**PATENT  
Attorney Docket No. 2002P84076WOUS**

**Title: BRUSH SEAL FOR SEALING A GAP BETWEEN A ROTOR AND A STATOR**

**APPELLANT'S BRIEF UNDER 37 CFR 41.37**

## EXAMINER'S ATTACHMENT A

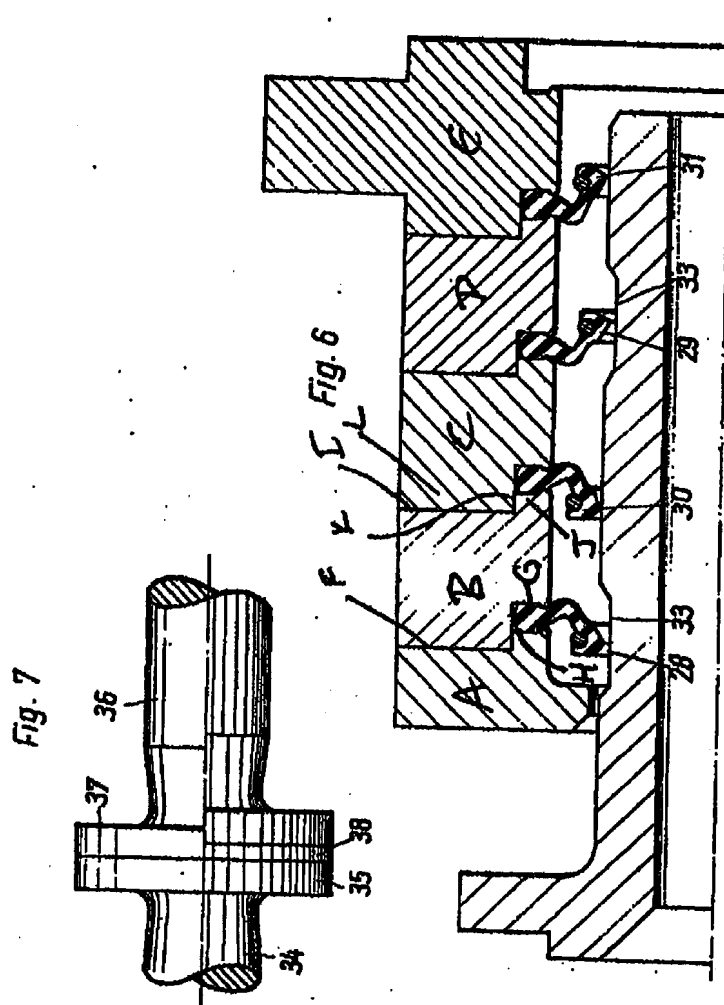
"Regarding claim 12, the Walter et al. reference discloses a seal (Fig. 6) sealing a gap between a rotor (e.g. 17) and a stator (e.g. 15) comprising: . . . wherein the second ring carrier is fixed to the first ring carrier by an unreleasable snap connection (Fig. 6), including the ring being a lip ring (Fig. 6)." Applicants respectfully assert that this is error and the rejection based on this erroneous conclusion must be reversed.

First as to this quotation, it is noted that reference is made to Fig. 6 but Examiner's Attachment C, sent with the Final Office action, provides Fig. 8, which is sheet 6 of 6. (It is noted that Fig. 6 was previously provided as Examiner's Attachment A in an earlier Office action.) The relevant features of Fig. 6 and Fig. 8 as to these arguments are identical, so reference above was made to both Fig. 6 and Fig. 8.

In the alternative, as stated previously in the 02/26/2007 Reply, the Walter et al. embodiment does not meet claim 12 as alleged because a lip ring as shown in Fig. 6 is not synonymous with an unreleasable snap connection. There is no snap connection in the common understanding of the term. Therefore construing of Walter et al. to provide a lip ring type of seal does not teach all limitations of claim 12. Further, as noted above, there is no teaching in Walter et al. that the structures comprise any kind of a snap connection.

Second, as stated in the 02/26/2007 Reply, applicants respectfully dispute the assertion that Walter et al. provides a "shoulder with a circumferential slot (K)." A slot may be defined as a "narrow notch, groove or opening" (Webster's New World Dictionary, 2<sup>nd</sup> Ed.) The flat expanse identified as I in Fig. 6 has only one raised boundary, the upper surface of J, and lacks a second opposing boundary that would define a slot, such slot being a narrow notch or groove. The Examiner states that "a slot does not need three boundaries as the applicant is alleging" (page 6 of Final Office action), yet to achieve the claim 14 requirement of "wherein the snap connection is formed between the circumferential slot and the latching nose" 14, there must be something for the latching nose to catch on. In Fig. 6 of Walter et al., there is nothing to catch on so the alleged "slot" does not meet this aspect of the claim. This is clear error based on overbroad definition of "slot" by the Examiner.

Also, in addition to the above paragraph Applicants respectfully dispute the assertion that Walter et al. provides a "latching nose" since a latching nose cannot reasonably be stated to be that "portion of element C attached to element J." As stated by Applicants on page 7, last paragraph of the February 26, 2006 Response, a latch, when referring to a fastening for a door or a gate, in part is stated to consist of "a bar that falls into a notch in a piece attached to a doorjamb or gatepost". (Webster's New World Dictionary, 2<sup>nd</sup> Ed.). Again, the concept of a notch, being

EXAMINER'S ATTACHMENT C

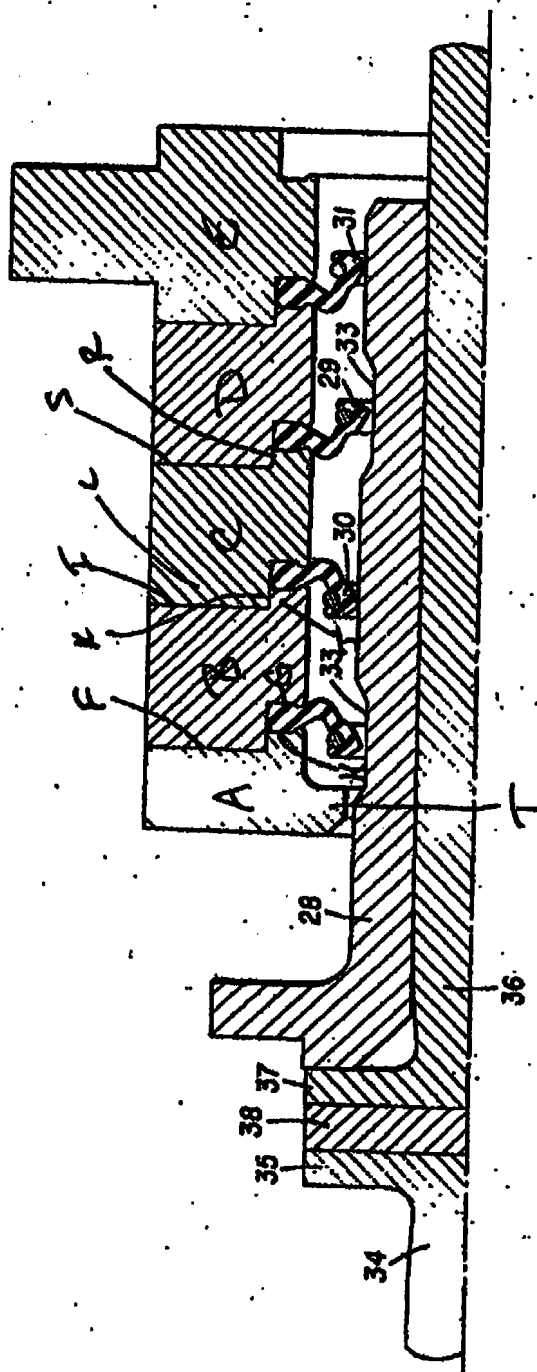
a "narrow pass with steep sides" or a "gap" does not comport with the stated features of Fig. 6 since there is no slot or notch into which may fit the noted portion of element C. (As further evidence of the lack of this feature, note that two opposing extensions are provided in Fig. 8 of Walter et al. to retain each sealing ring (29, 30) top portion in the sealing ring holders. If Walter et al. meant to show a latching nose where the Examiner alleges there is one, it would have an inflection from the linear somewhat like that shown to retain sealing rings 29 and 30 in the same figure (even if functions were different).) Therefore, based on one or more of these issues, in part based on common understanding of the meaning of relevant terms, there is clear error by the Examiner and these bases for the rejection of claim 14 should be withdrawn.

In the Final Office action, pages 6-7, the Examiner essentially selects unsuited definitions to support the alleged existence of elements from claim 14 in Examiner's Attachment C/FIG. 8 of Walter et al. As discussed above, the exercise results in an extreme broadening of the terms' definitions to the point of an illogic consequence: if one accepts all of the meanings offered by the Examiner, where is the unreleasable snap connection? First (skipping the definition offered for "snap-on" which is discussed for claim 12 above and is incorporated here), the Examiner states that a slot need not have three boundaries. No support is provided, nor is there an explanation as to how the slot alleged to exist in FIG. 8, stated to be "the upper surface of J and the surface I," combine to provide the unreleasable snap connection with the latching nose. As to the latter, the Examiner states that "the latching nose would only have to be considered as a bar, which element L is clearly shown as in Figure 6 [sic] of the Walter et al. reference." Such selective defining of the terms may be tempting but in this case inexorably leads to the point of illogic: again, how do these elements combine to form an unreleasable snap connection? They do not, and it is clear error to make this rejection based on these overbroad definitions that are unsuited to the invention at issue.
